L190-E980633-00-D

ENGINEERING CHANGE REQUEST (ECR)

CUSTOMER DRAWING NO. 972701

DRAWING TITLE ~~972~~ HAM stack Assy.

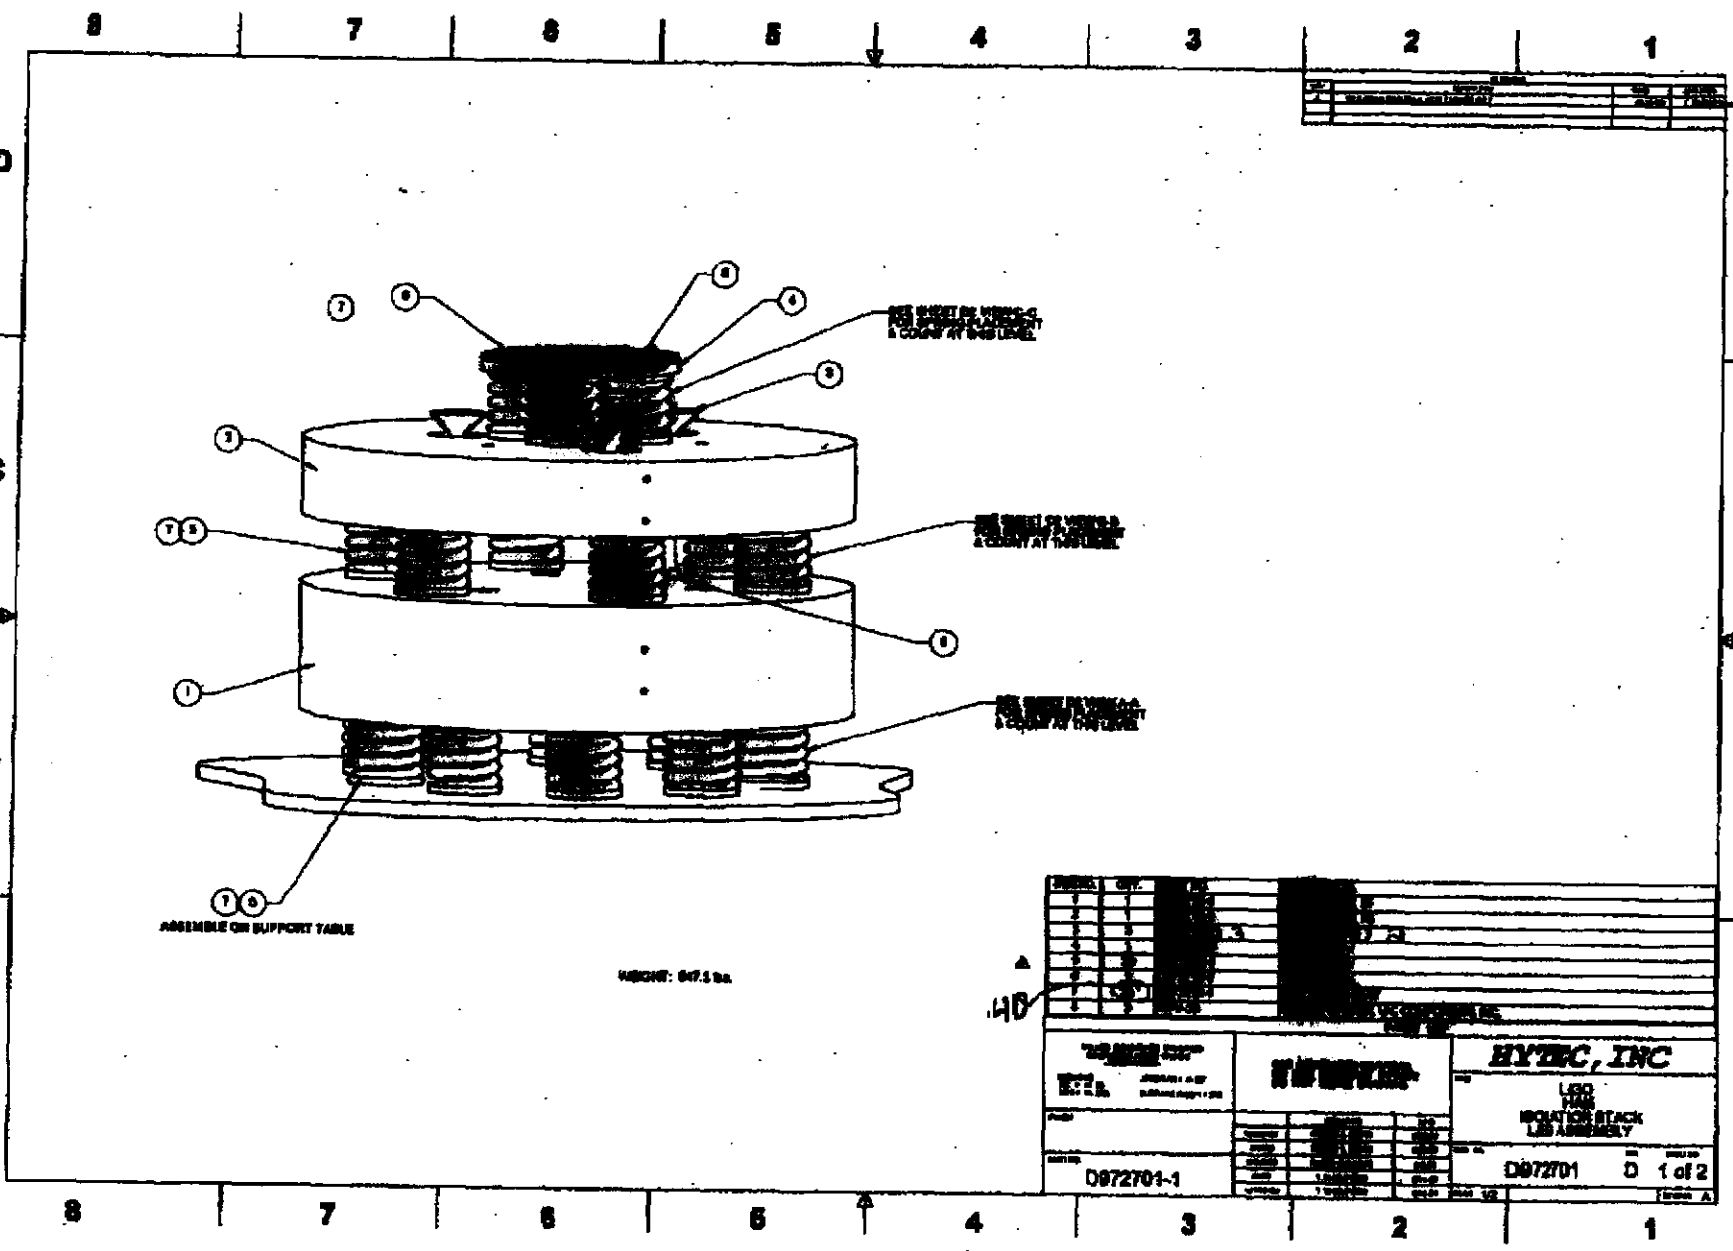
item (3) change from D972715-1 to D972715-3
Leg screw #2

incorrect callout
